CONSERVATION COMMISSION AGENDA

The Conservation Commission will hold this meeting as a virtual meeting on Thursday, November 19, 2020 at 7:00 pm. No in-person meeting will take place at City Hall.

1. **Zoning Redesign – Community Engagement Update Presentation**
 - **Presenter:** Nevena Pilipovic-Wengler, Community Planning/Engagement Specialist
2. **1000 Commonwealth Avenue (City Hall Ponds) – OOC – pond dredging – DEP File #239-878**

EROSION AND SEDIMENT CONTROL & CONTROL OF WATER PLAN

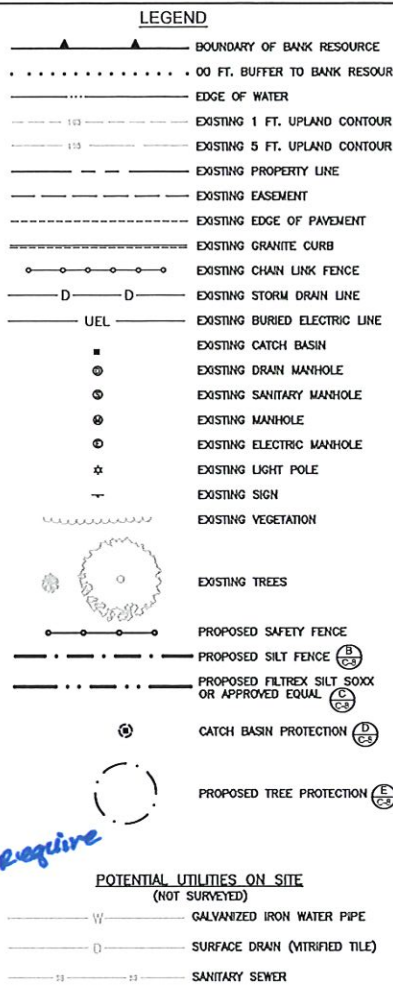
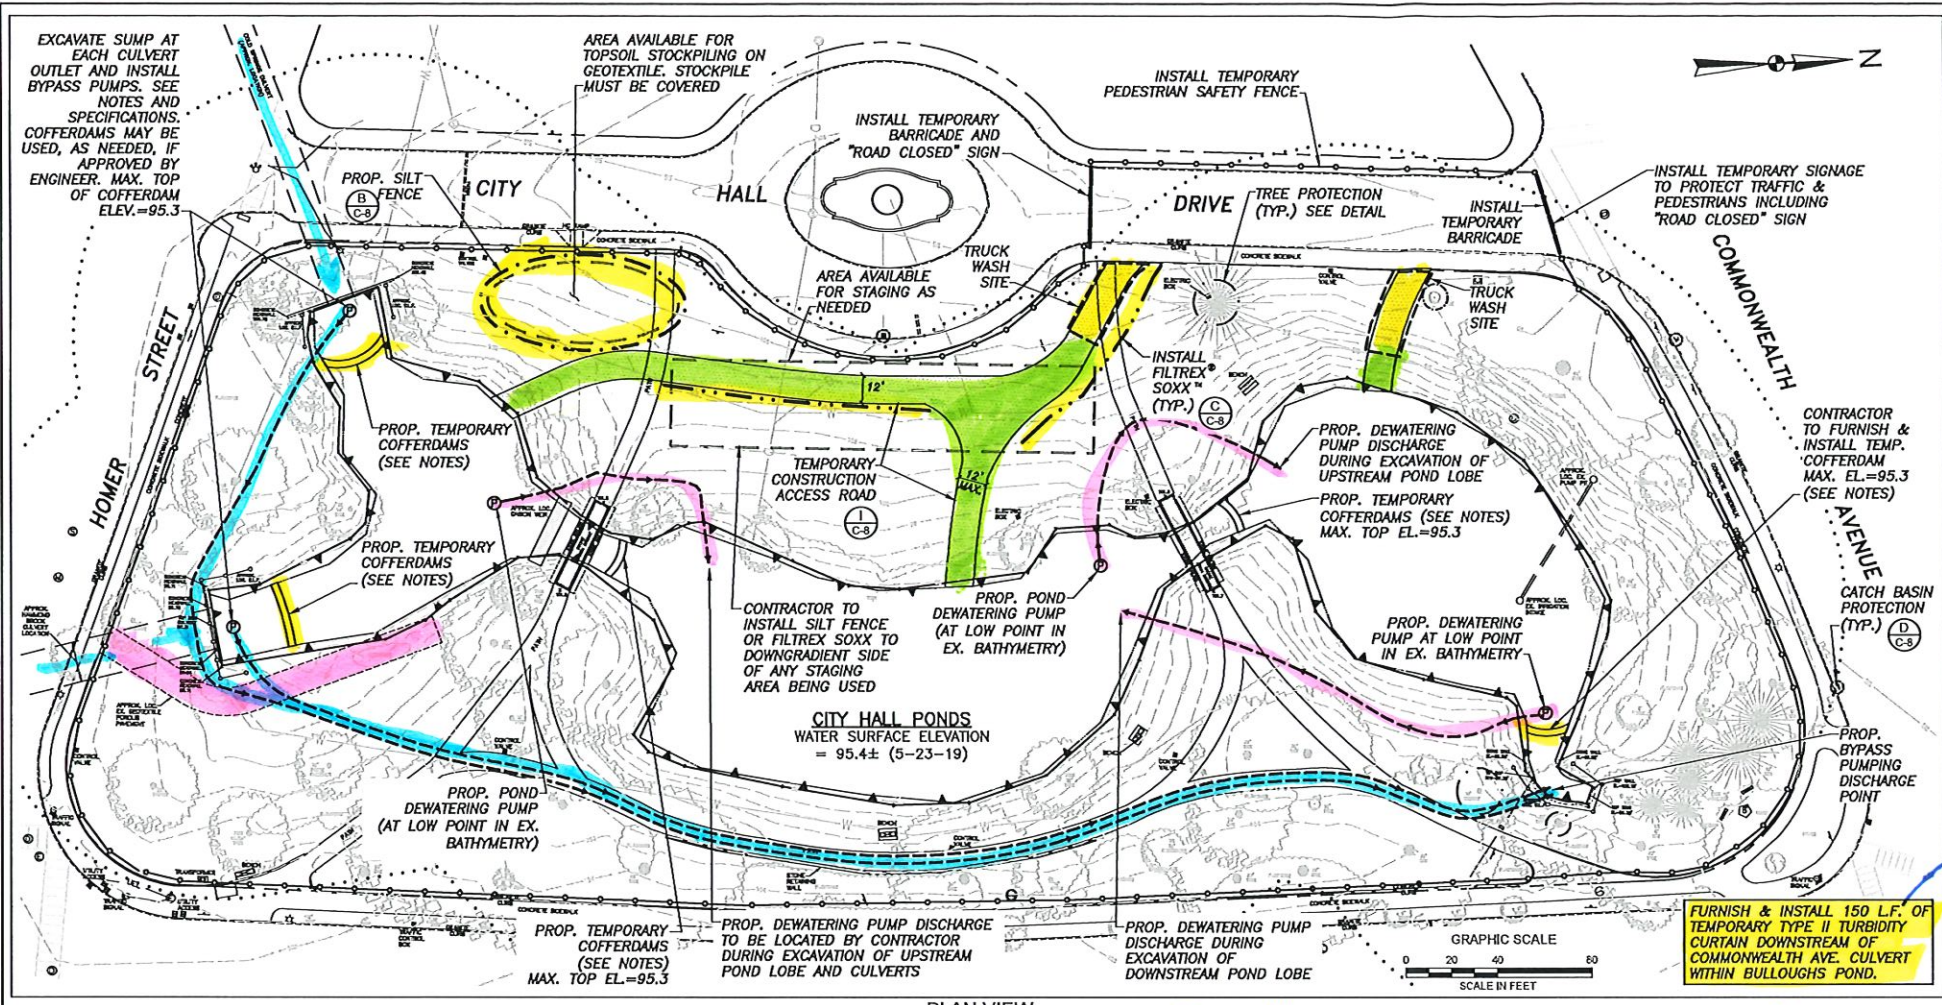
SWPPP must be submitted to ConCom

add loan see C-7 Restoration #4 = Sod

which one? detail?

add loan (see above)

- Plan sheet C-6 notes that dewatering effluent will be addressed in some way. ConCom must approve the proposed plans. Narrative says “During excavation of the most downgradient pond lobe, a separate dewatering best management practice (BMP) will be used to treat pumped dewatering flows prior to discharge. Contractor shall select and operate BMP(s) based on specific site conditions present at that time, with the BMP required to be reviewed and approved by the Engineer prior to use. ConCom must approve any dewatering plans.

- Dewatering must occur as noted on plan sheet C-6.
 - Turbidity curtain must be installed as noted on plan sheet C-6.
 - Construction Notes 8, 9, 12, 13, 14 on plan sheet C-7 must be adhered to.

POND RESTORATION PLAN

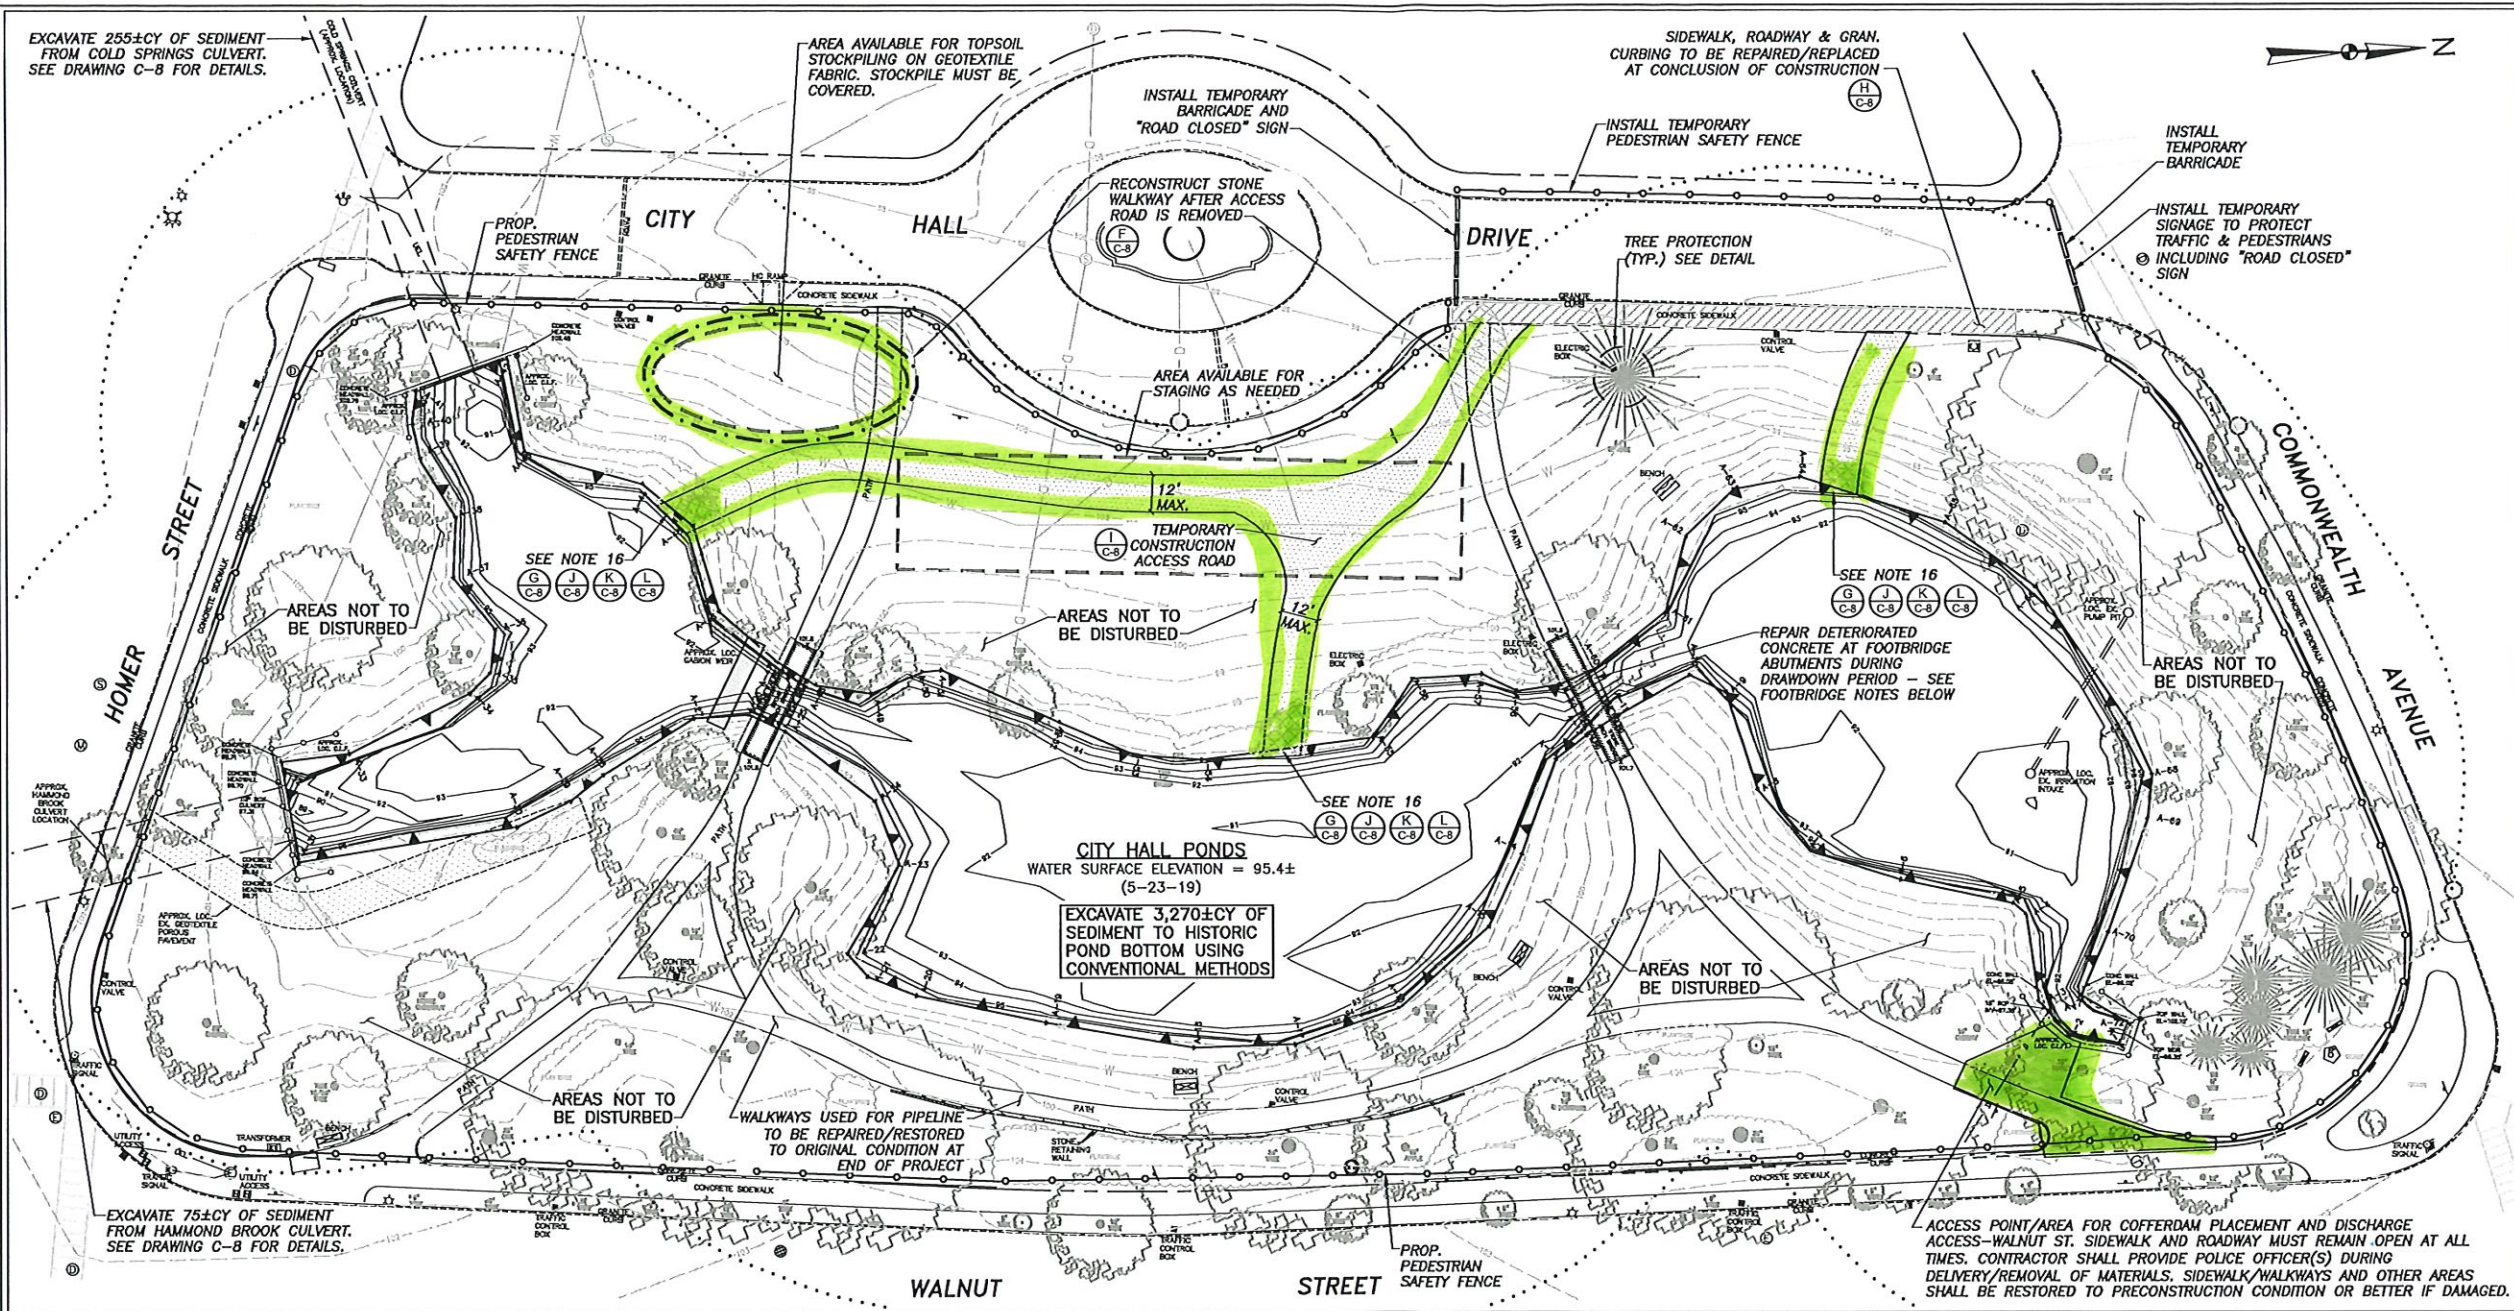
- In general, ConCom must approve any changes, details proposed. (See NOTES 1 and 3 on C-6)
- Applicant should provide revised sheets that provide one plan for site restoration, as currently site restoration plans vary among the narrative, and the different plan sheets, from seed, to loam and seed, to loam and sod.

- Sediment Excavation Note 2 on plan sheet C-7 must be adhered to.
 - Footbridge Repair Notes 1, 4 on plan sheet C-7 must be adhered to.
 - Restoration Note 4 on plan sheet C-7 must be adhered to.

DEMO AND EXISTING COND. C-105

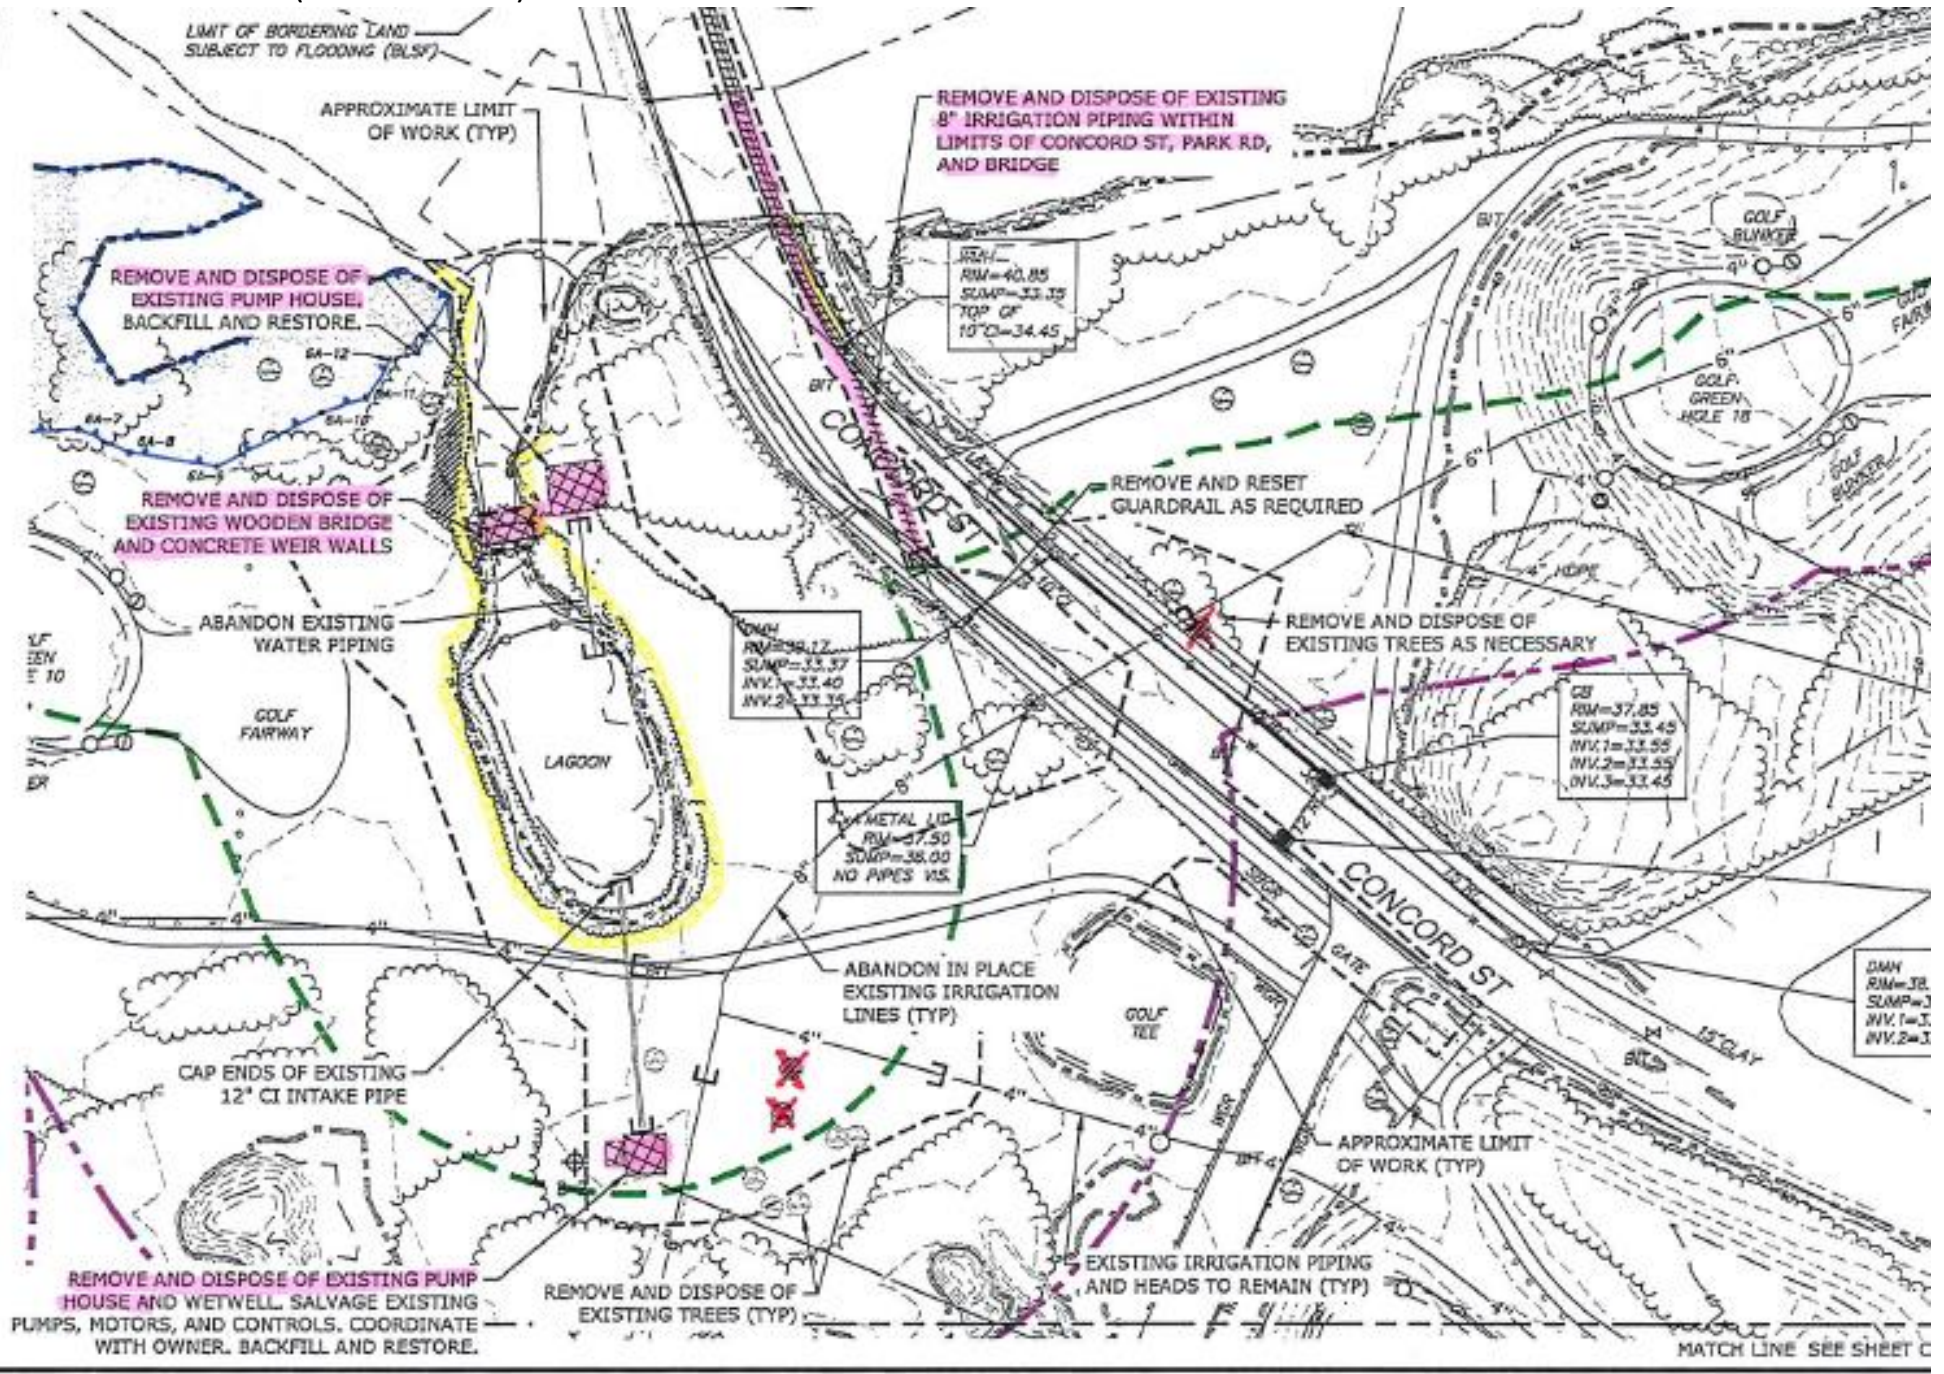
- Dredging access will be from the south side for less disturbance.
 - Plantings have been revised to include 52 trees and 47 shrubs.
 - Applicant should correct Sheet C-105, which shows the wrong trees as to be removed.

C-109

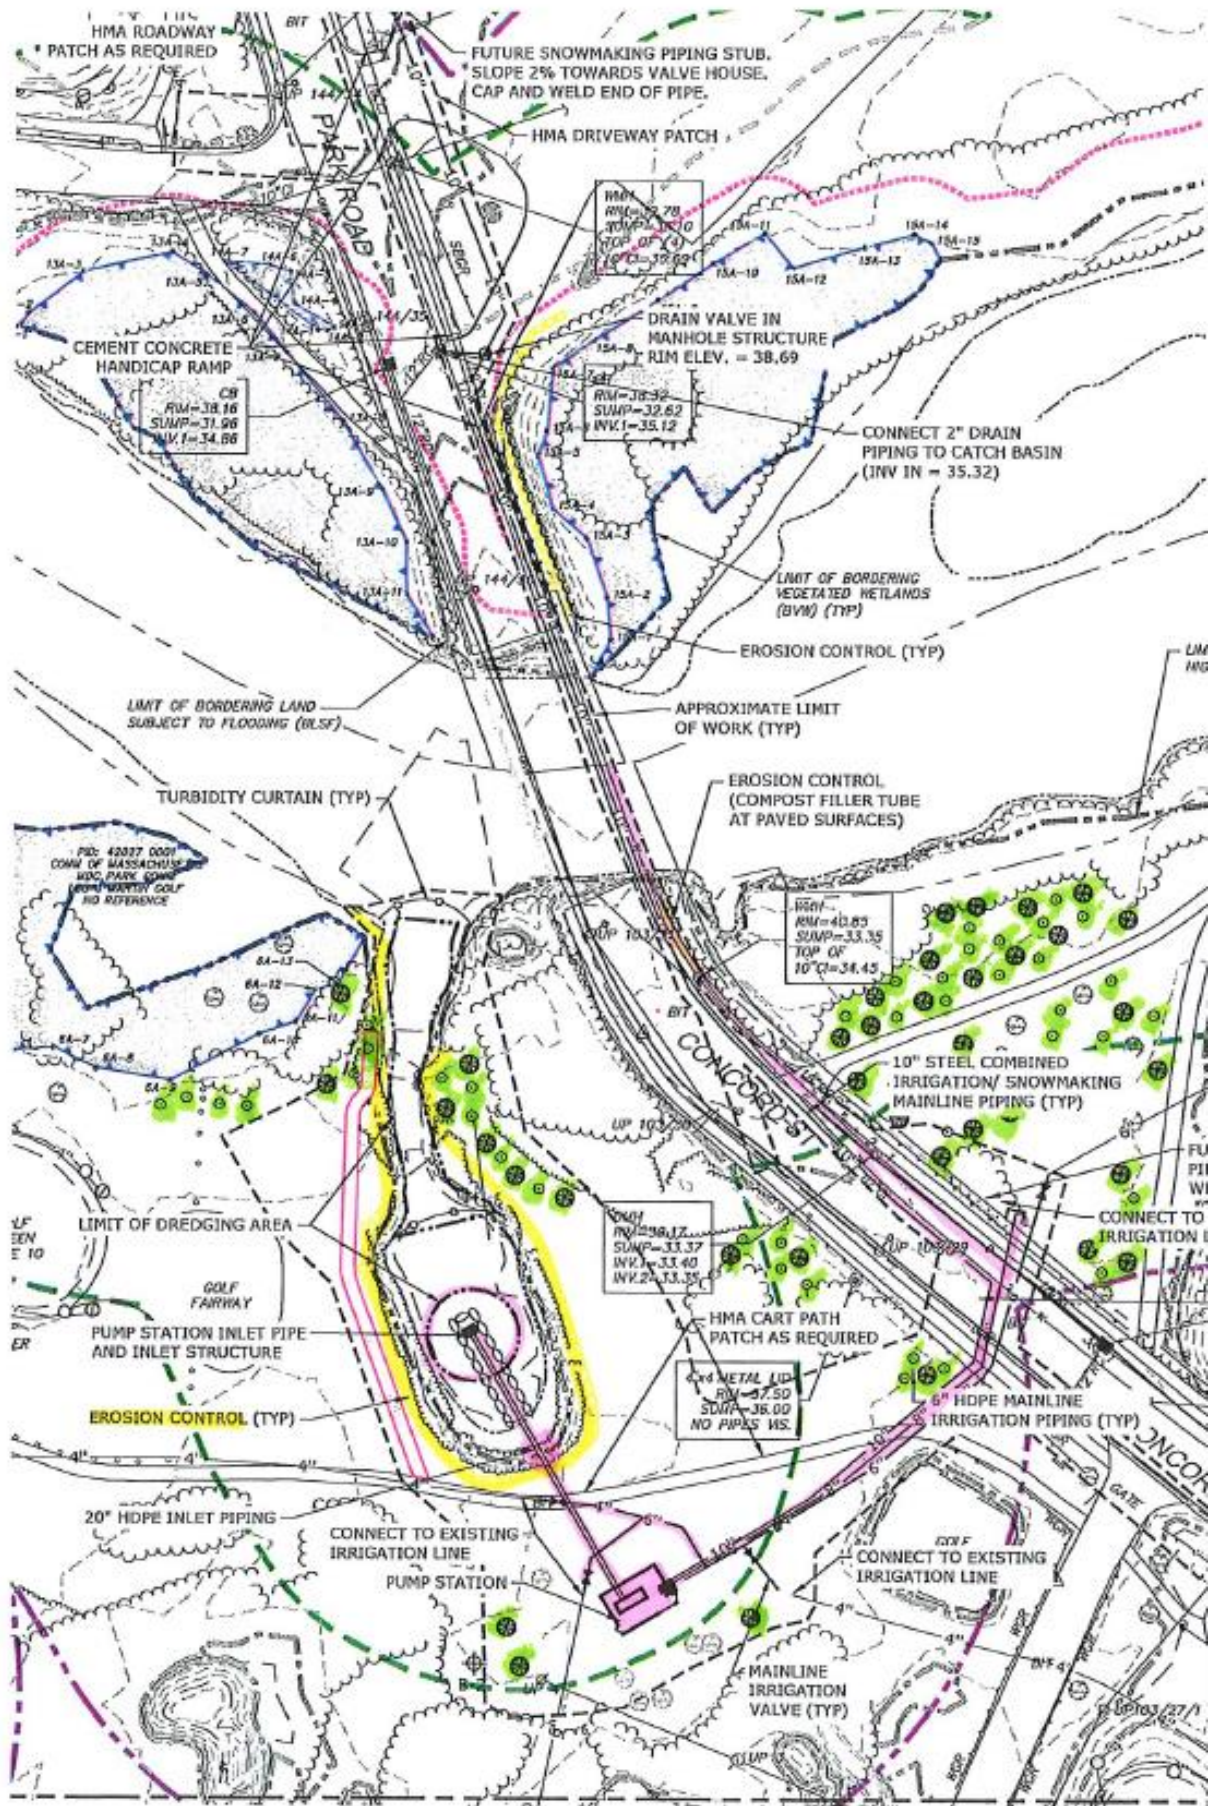
- Applicant should clarify where on Sheet C-109 and C-110 where erosion controls and snow fencing will be installed.
 - Staff counted 47, not 49, shrubs on Sheet C-110A.
